**Ref:** P/24/021/HH and 022/LBC  
**Address:** Parkside, The Parade, St Mary's  
**Grade:** II  
**First Listed:** 1975  
**List Description:** <https://historicengland.org.uk/listing/the-list/list-entry/1141190?section=official-list-entry>

Site Visits Notes: 13/05/2024

Ground Floor  
Existing

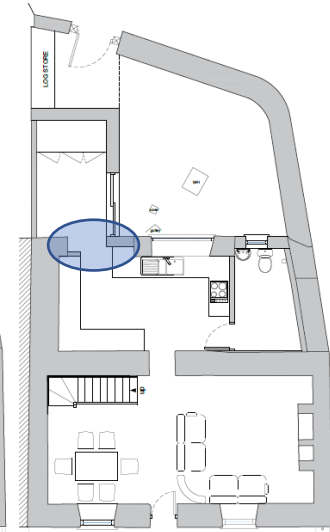
There is no issue with this in principle as the existing garage appears to be a relatively modern addition and detracts from the rear of the house. Details of the new door / gate to the back lane should be provided. It would appear that this is used for storage only, not vehicles. The plans will need to be drawn to an appropriate scale with full details of all proposed materials (doors, windows, roof finish, any rooflights, wall finishes etc) and service routes especially showing how it will link to the main house. **The existing opening from the g/f bathroom is a small window and the new opening will need to be detailed more clearly in addition to the new gate:**

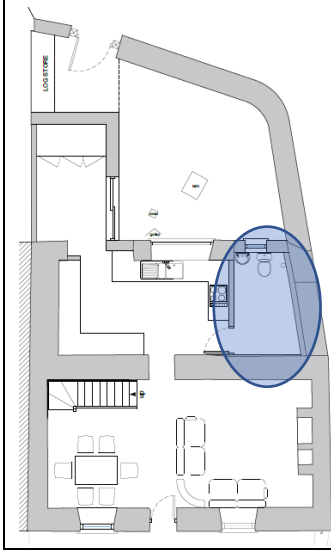
Wet rooms can cause significant damp problems in historic buildings, so this will need to be carefully detailed and the drainage / service route details provided. **I would expect to see much more detailed drawings at an appropriate scale.**

Ground Floor

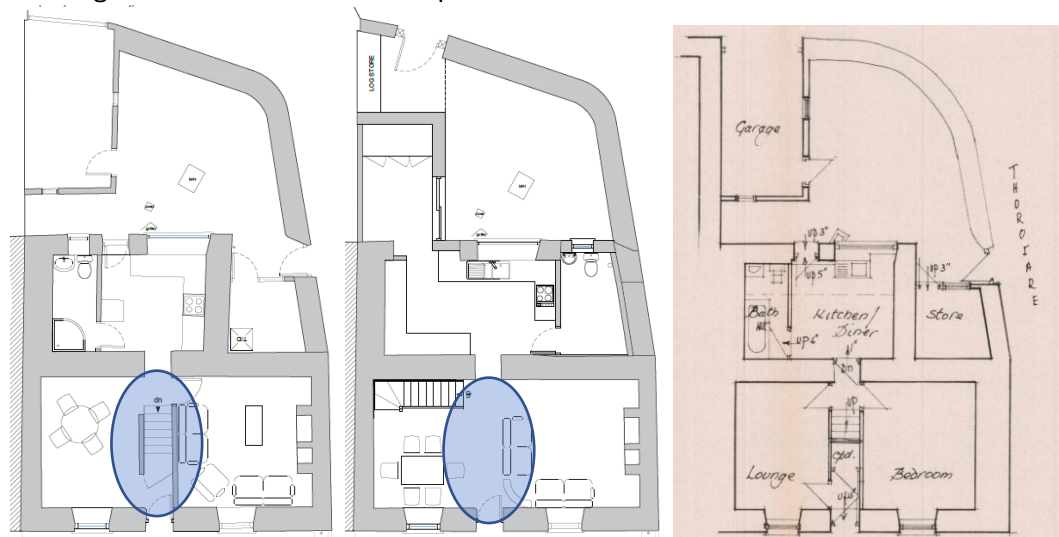
The listing description specifically notes that the stairs are central, forming the two rooms on the ground floor. This seems to be a feature of these houses and is therefore likely to be the original layout. I note that all finishes are sealed with no visible parts beneath render or stairs could be seen. Similarly, no banister details were evident. Based on submitted plans from 1987, and nothing to suggest the stairs are modern, I have to assume that the stairs are original. Although they could have been repaired I don't consider an adequate case has been made to demonstrate these are not original – should the applicant wish to remove the stairs we would need to be presented with evidence that these are not original. As it stands there is no justification to reposition the stairs and create an open plan layout. I consider it is likely to have a significant impact on its historic layout and character of the cottage as well as requiring potentially historic joists to be cut through. Plans approved previously for works to this property appear not to have been implemented and the plans at the time also reflect the current stair arrangement. **This aspect of the proposal is not supported.**

First Floor  
1987

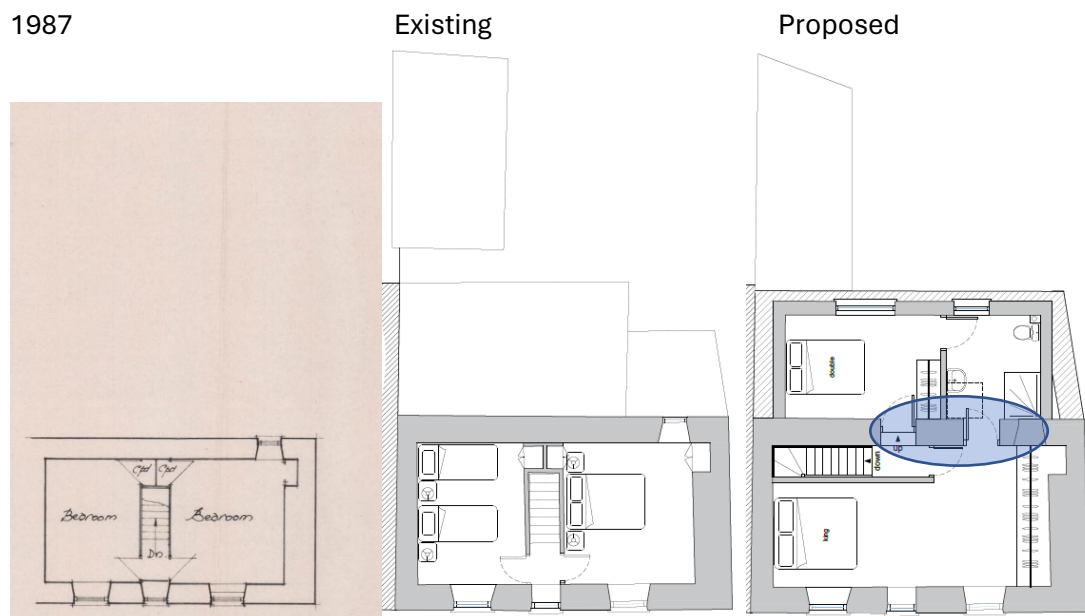
This large extension requires an additional opening in the upper external wall, and as it has already lost some of historic character and features due to some unsympathetic previous alterations, it is important to retain as much as possible now. **I would suggest that the proposals are amended to reconfigure the upstairs layout, significantly reducing the size of the proposed extension, so it can use the existing opening (above the shed) without having to open up the rear wall further.** Although there are large extensions within the terrace but I note that Pelistry Cottage (next door but 2) was permitted to have a rear floor roof replaced with a pitched roof in 2007 (P/07/005 and 006) but this would appear to have made substantial improvements to a lower quality existing extension, next door but 1 (Bar Escapade) is not listed, and the immediate neighbour, Armorel, although has a pitched roof extension, this would appear to pre-date its listing.

No evidence that extension was erected after listing
